Village of Arlington Heights
Conceptual Plan Review Committee
Community Room, 3rd Floor
Arlington Heights Village Hall
33 S. Arlington Heights Road
Arlington Heights, IL 60005
January 9, 2019
6:30 PM

VILLAGE OF ARLINGTON HEIGHTS
STAFF DEVELOPMENT
COMMITTEE REPORT

VILLAGE OF ARLINGTON HEIGHTS **STAFF DEVELOPMENT** **COMMITTEE REPORT**

VILLAGE OF ARLINGTON HEIGHTS **STAFF DEVELOPMENT** **COMMITTEE REPORT**

A.L.T.A. / A.C.S.M. LAND TITLE SURVEY

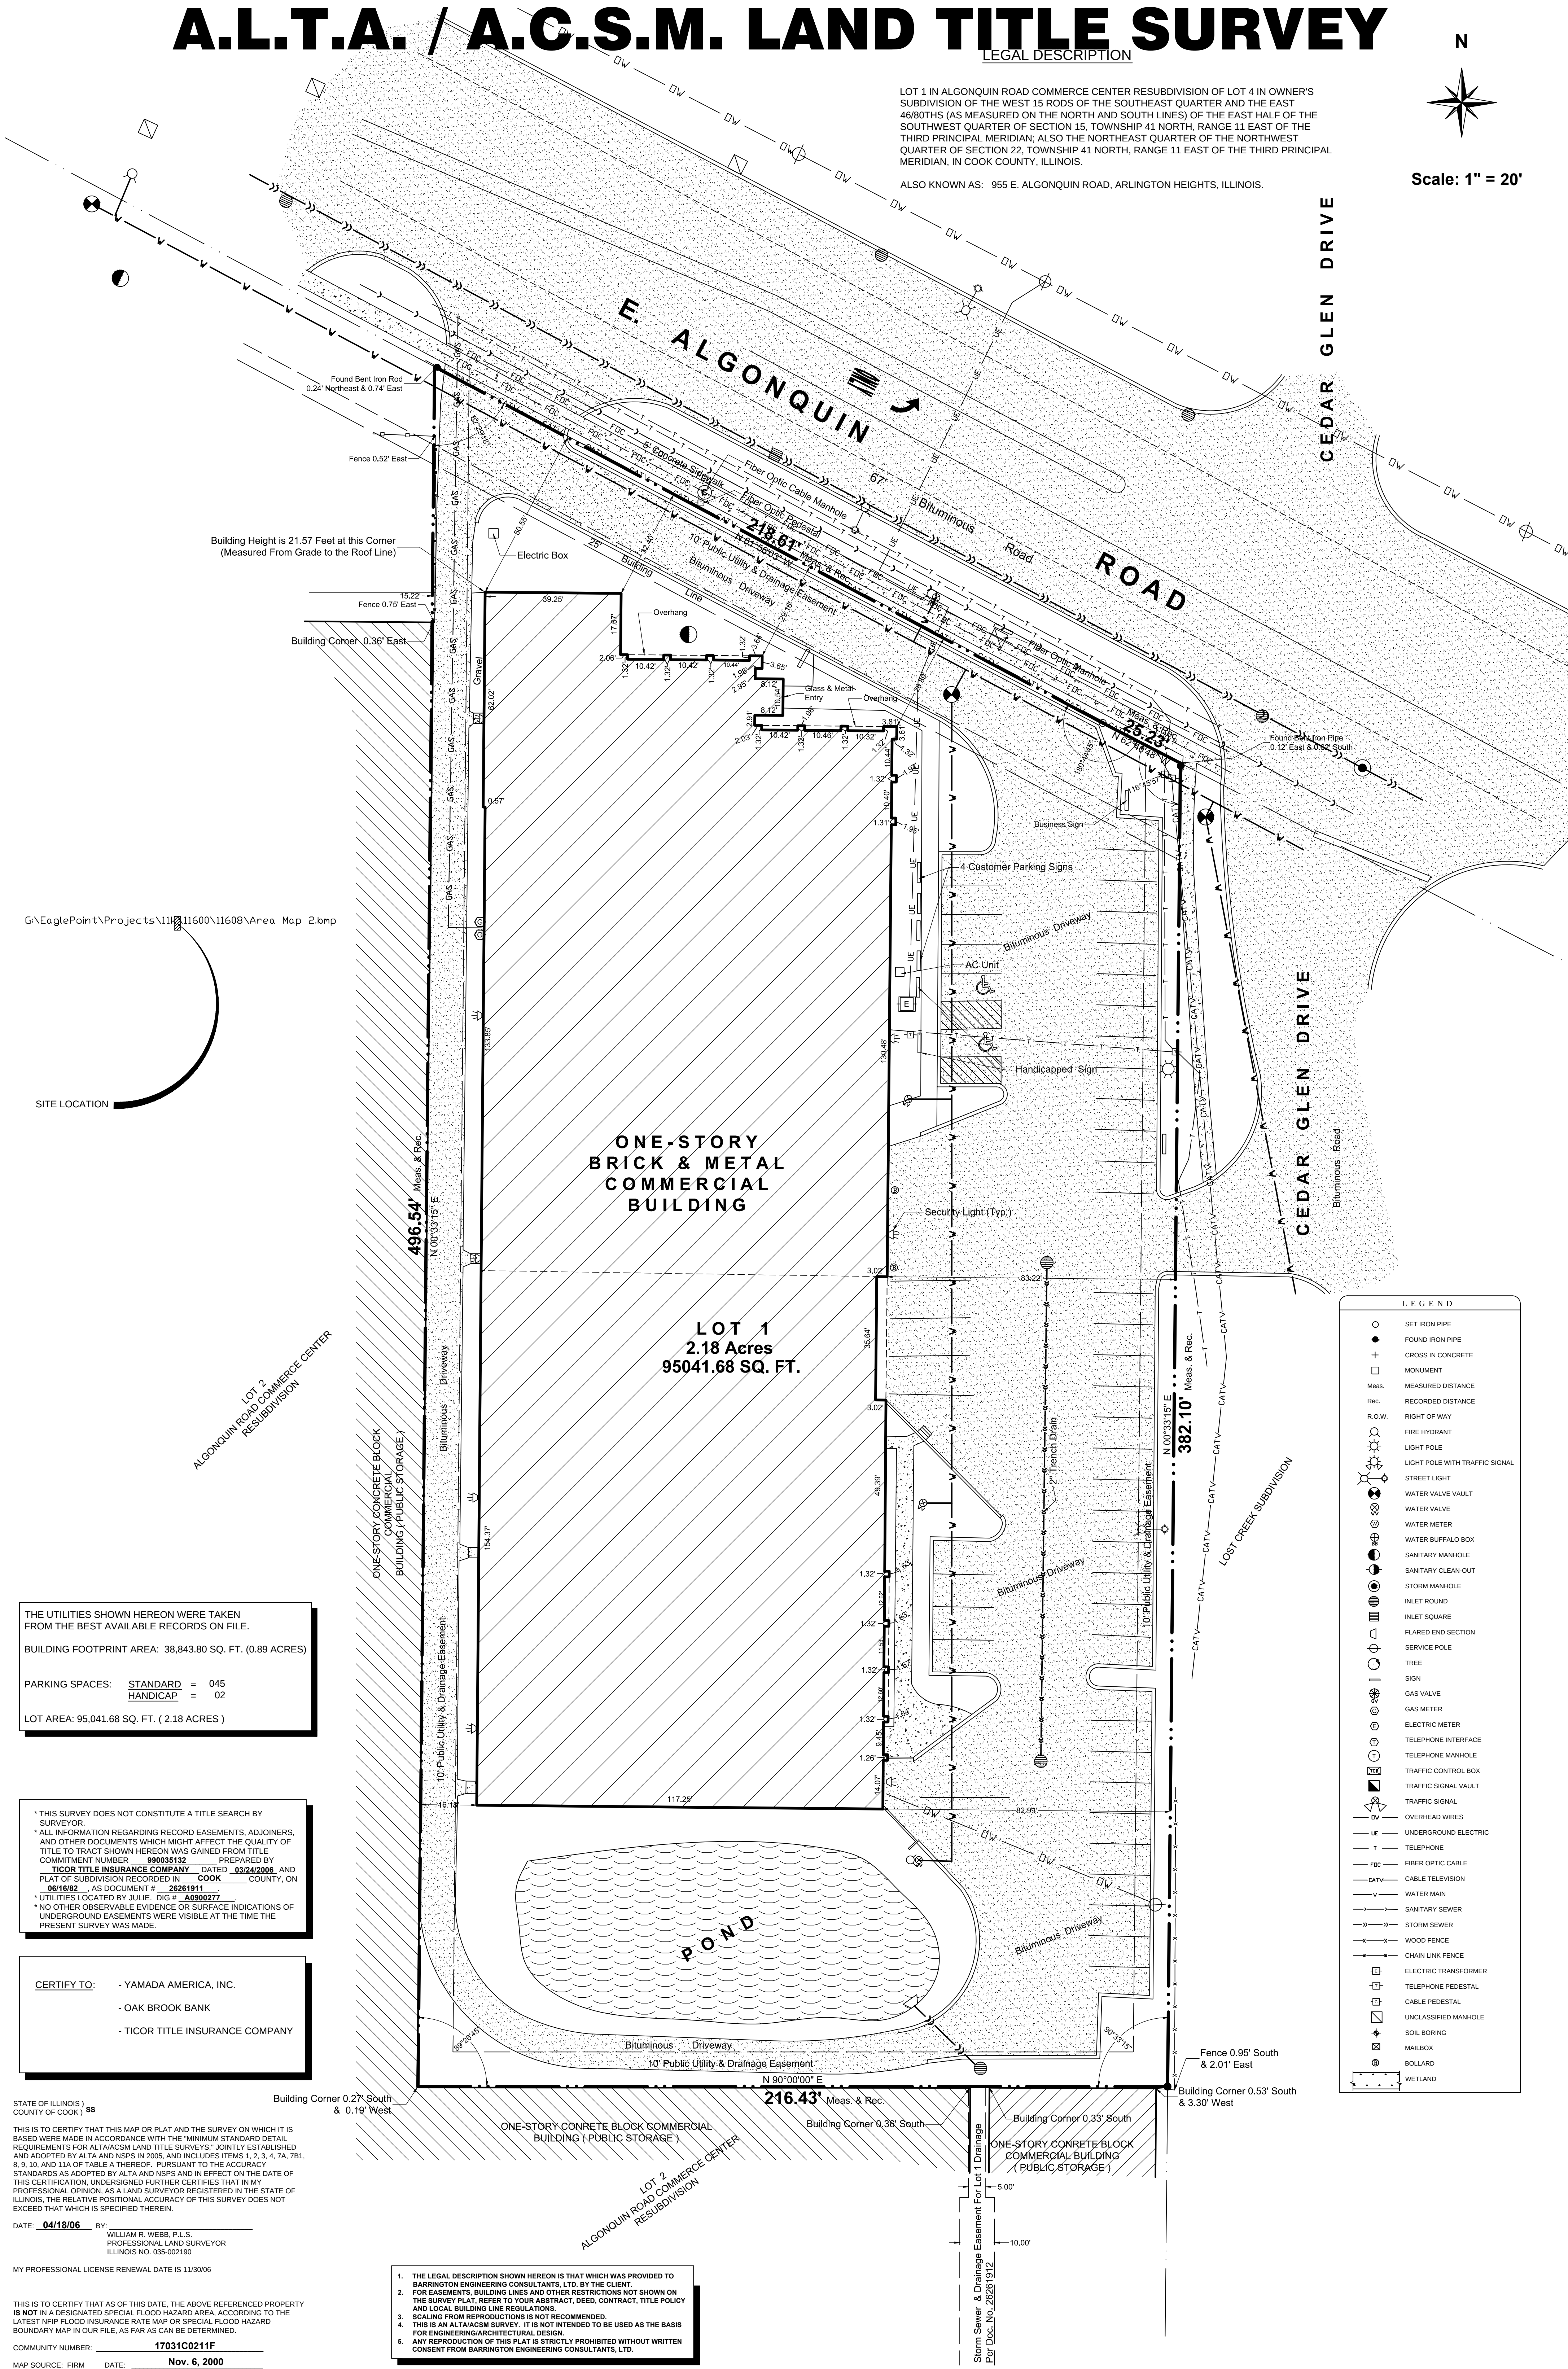
The existing drive aisle on the north side of the site is 11' wide with four 9' wide parallel parking stalls along one side, which spaces were not shown on any of the original plans approved for this development. The drive aisle lacks the minimum required drive aisle width to support parallel parking and it should be noted that the petitioner is proposing to shift these four parking stalls further down the drive aisle to allow for enhanced maneuverability. However, since the drive aisle does not meet the required width, the following variation is necessary:

The petitioner must provide the necessary justification for said variation, or must modify the drive aisles so that they conform to code requirements. Staff notes that these four parking spaces are needed to comply with parking requirements.
